REF: SPR-5-23
DATE: June 8, 2023

Request	-	Appeal of Conditions of Approval for Minor Site Plan Review for a New Building
Location	-	952 Matzinger Road
Applicant/Owner	-	Todd Alspaugh Todd Alspaugh & Associates 5353 Secor Road Toledo, OH 43623
Engineer	-	Jeff Ruch Engineers, Surveyors & Associates 4841 Monroe Street, Ste. 103 Toledo, Ohio 43623

MINOR SITE PLAN REVIEW 952 MATZINGER ROAD PART OF THE NW 14 OF SEC. 18, T9S, R6E, CITY OF TOLEDO, LUCAS COUNTY, OHIO

SITE PLAN
SITE IMPROVEMENTS & STORAGE BUILDING
952 MATZINGER ROAD
CITY OF TOLEDO, LUCAS COUNTY, OHIO

C1.0

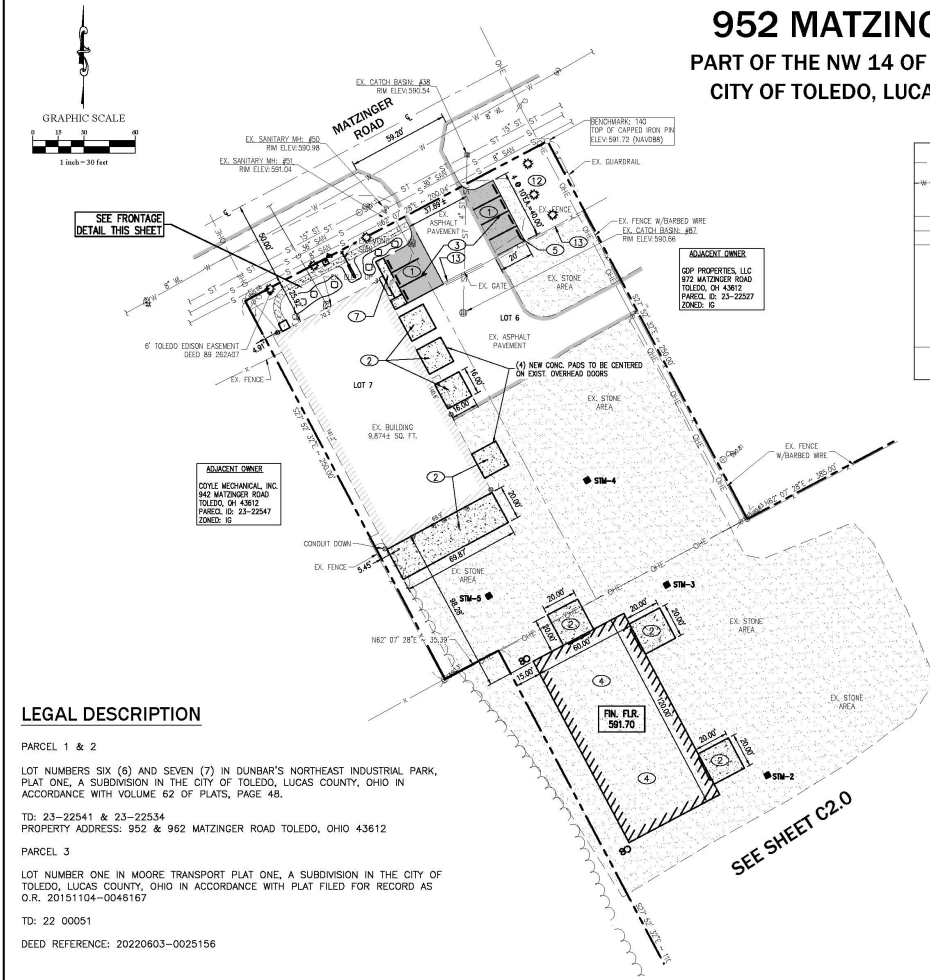
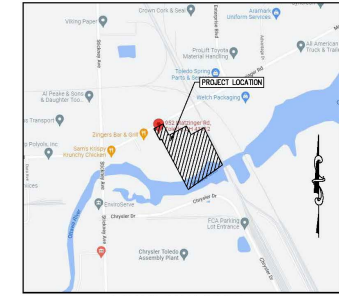
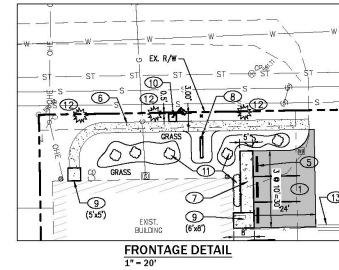
- **#19:** Sidewalk along Matzinger Road is required per TMC 1107.1300.

- **#22:** All off street parking and loading spaces, parking lots, maneuvering areas, drive aisles and driveways must be surfaced with concrete, asphalt, or other dust-free material other than gravel or loose fill per TMC 1107.1906.

#27: Off-street parking and loading spaces, parking lots, maneuvering areas, aisles and driveways must be surfaced with concrete, bituminous asphalt, or other dust-free material other than gravel or loose fill, and be graded to drain all surface water towards the interior of the parking lot TMC 1107.1906. **Parking spaces and drive aisles to all rear building entrances shall be in compliance with this section unless a variance from the Board of Zoning Appeals is obtained. Paved drive aisles shall be a minimum of 25'. Shall be submitted on a revised site plan.**

18. Bicycle parking is required per TMC 1107.0900.
19. Sidewalk along Matzinger Road is required per TMC 1107.1300.
20. One 9'x18' van accessible parking spot with 8' wide loading area is required per TMC 1107.1701.
21. Accessible parking signage is required per TMC 1107.1704.
22. All off street parking and loading spaces, parking lots, maneuvering areas, drive aisles and driveways must be surfaced with concrete, asphalt, or other dust- free material other than gravel or loose fill per TMC 1107.1906.
23. If one has not already been established, a cross access with the adjacent property to the northeast is required.

26. Off-street parking is prohibited within the thirty (30’) foot parking lot setback TMC 1107.1202(B). **Not acceptable as depicted. Staff is supportive of a revised agreement reducing the number of spaces from seven to three in the required front setback. A variance from the Board of Zoning Appeals must also be obtained. Shall be submitted on a revised site plan. [REVISED]**

27. Off-street parking and loading spaces, parking lots, maneuvering areas, aisles and driveways must be surfaced with concrete, bituminous asphalt, or other dust-free material other than gravel or loose fill, and be graded to drain all surface water towards the interior of the parking lot TMC 1107.1906. **Parking spaces and drive aisles to all rear building entrances shall be in compliance with this section unless a variance from the Board of Zoning Appeals is obtained. Paved drive aisles shall be a minimum of 25’. Shall be submitted on a revised site plan.**

30. Dumpster location(s) shall be clearly defined, have a concrete pad and be surrounded by a solid wooden fence or a masonry screen enclosure with landscaping and shall not be located in any required setback. **Not acceptable as depicted. Shall be submitted on a revised site plan.**

- a. Per TMC 1108.0202, a thirty-foot (30’) frontage greenbelt is required along Matzinger Road and shall include at least one (1) tree per every thirty feet (30’) of frontage or fraction thereof. **A total of seven (7) trees shall be planted. Trees and the 15’-30’ greenbelt shall be indicated on a revised site plan. Greenbelt is reduced near parking areas. [REVISED]**

- Currently there are no sidewalks on either side of Matzinger Road from Benore Rd. to Dura Ave., a distance of over 2 miles. We are concerned about the "bridge to nowhere" look. Further, per TMC 1107.1303 dealing with sidewalks in commercial districts, "sidewalks are to be constructed along public streets, at the time of development, of any parcel in any Commercial District." Would this apply as our parcel is already developed?

- As shown on our site plan, asphalt pavement for parking and shop entrances on the east side of the existing building will be paved with asphalt. Due to the nature of our business, Todd Alspaugh and Associates operates steel tracked construction equipment that will damage asphalt and concrete pavement during any turns. We will request a variance from the Board of Zoning Appeals for this. The drawings currently depict the area in question as existing gravel. The surface is recycled asphalt. Would that surface be considered dust-free by the City of Toledo? The approaches into the proposed building will be concrete pavement.

Disapprove a waiver to remove the requirement for the sidewalk along Matzinger Road.

Disapprove a waiver to allow parking lots, maneuvering areas, aisles and driveways without concrete, bituminous asphalt, or other dust-free materials.
